3100 RIVER WALK AVENUE (COMPLETE APPLICATION)
DE416120 - ZONE CD-1

DEVELOPMENT PERMIT STAFF COMMITTEE MEMBERS

EXECUTIVE SUMMARY

DEVELOPMENT PERMIT STAFF COMMITTEE RECOMMENDATION: APPROVE

L2.00

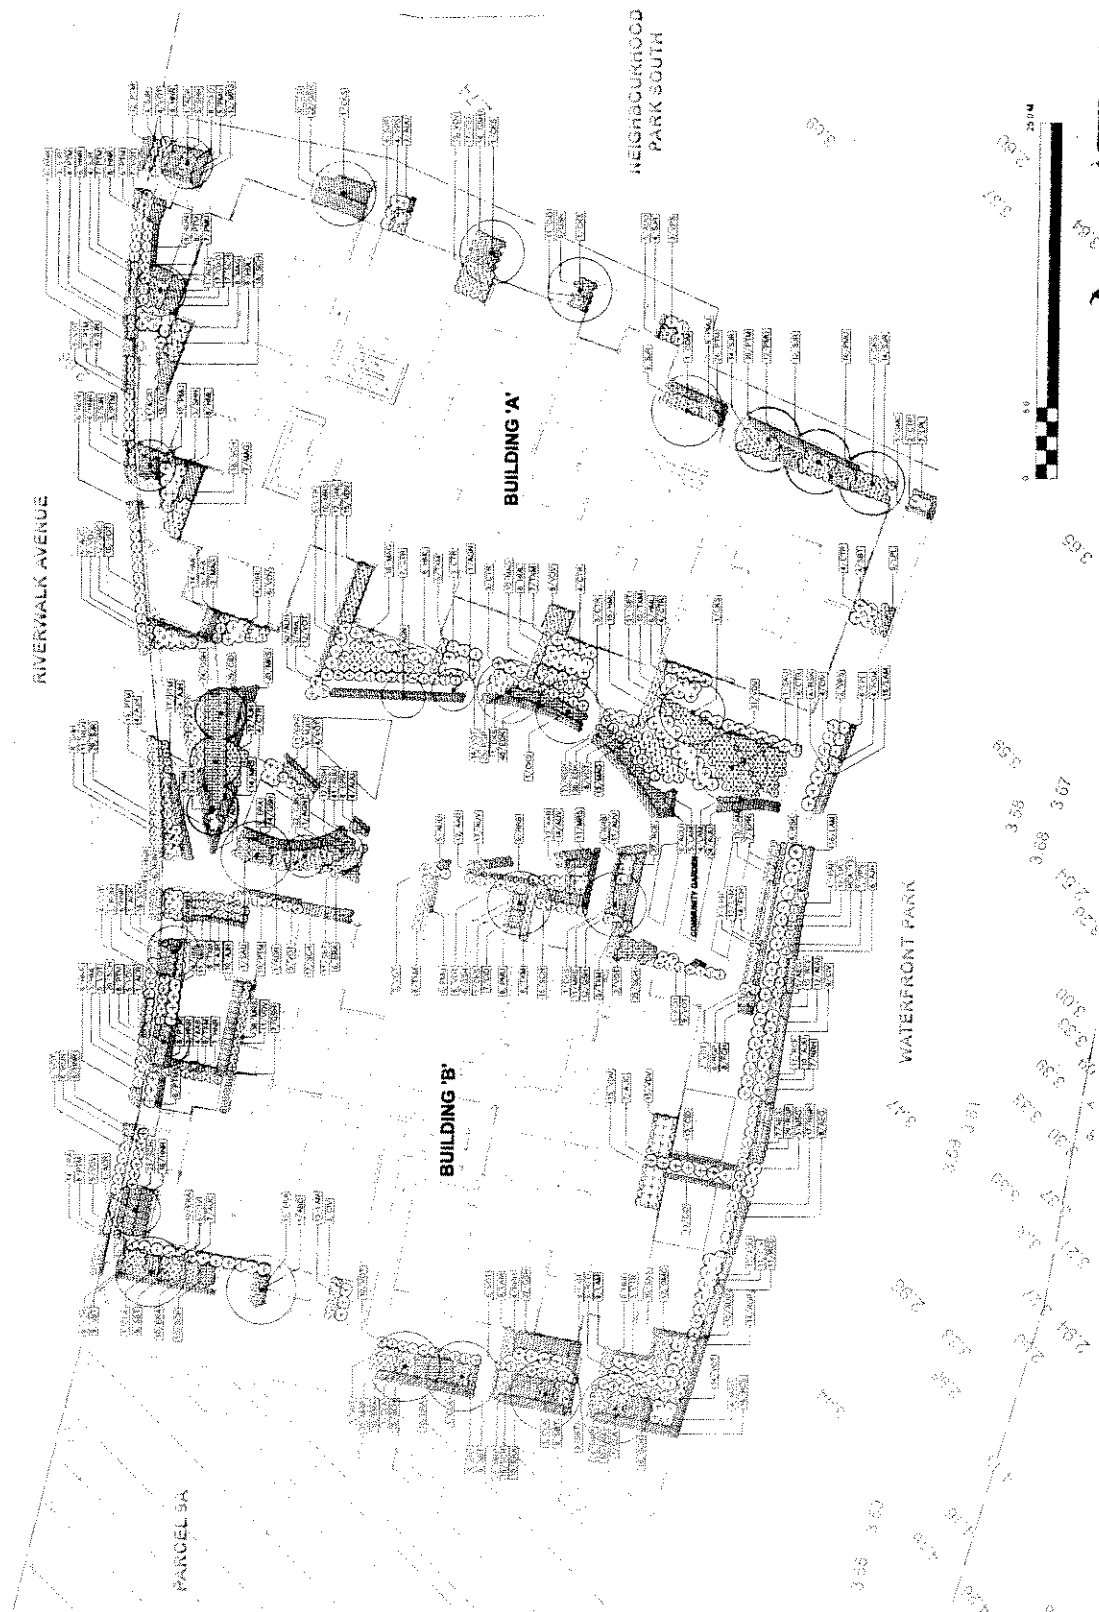
A.2.1 deletion of the small projection shown over the south property line on drawing A203 and portions of the trellis shown over the south property line on drawing L2.00 (section B);
